**PRELIMINARY DRAINAGE REPORT AND MDDP ADDENDUM
FOR
HOMESTEAD NORTH AT STERLING RANCH PRELIMINARY PLAN**

Engineering Review

EPC Planning & Community
Development Department

**PCD Filing No.:
SP-20-008**

EARLY GRADING - DRAINAGE MAP
HOMESTEAD NORTH
JOB NO. 25188.00
02/12/21
SHEET 3 OF 4

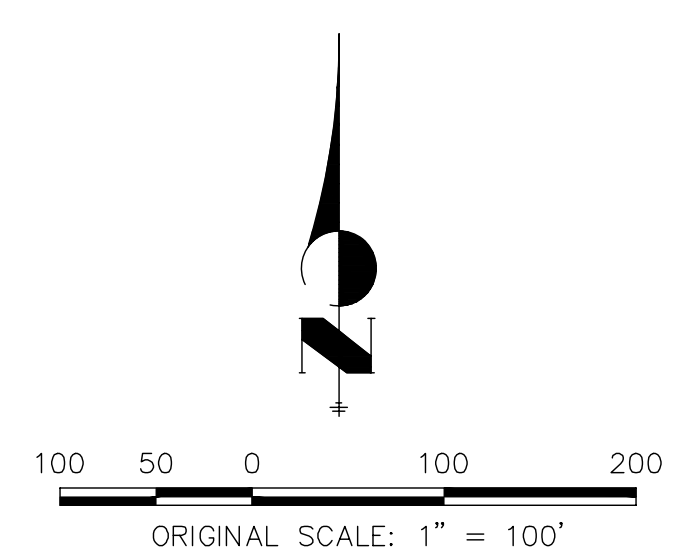
Provide basin and DP summary tables

Show grading
necessary to drain
these areas

What is the flow in the road?
it seems like a separate
channel is necessary with
rundowns from the road
where appropriate and
ditchouts on the south.

JR Response: Added

JR Response:
culvert added within
this area

JR Response: An interim swale
has been added to the northern
side of the road. Road and utilities
will be provided in a separate
report
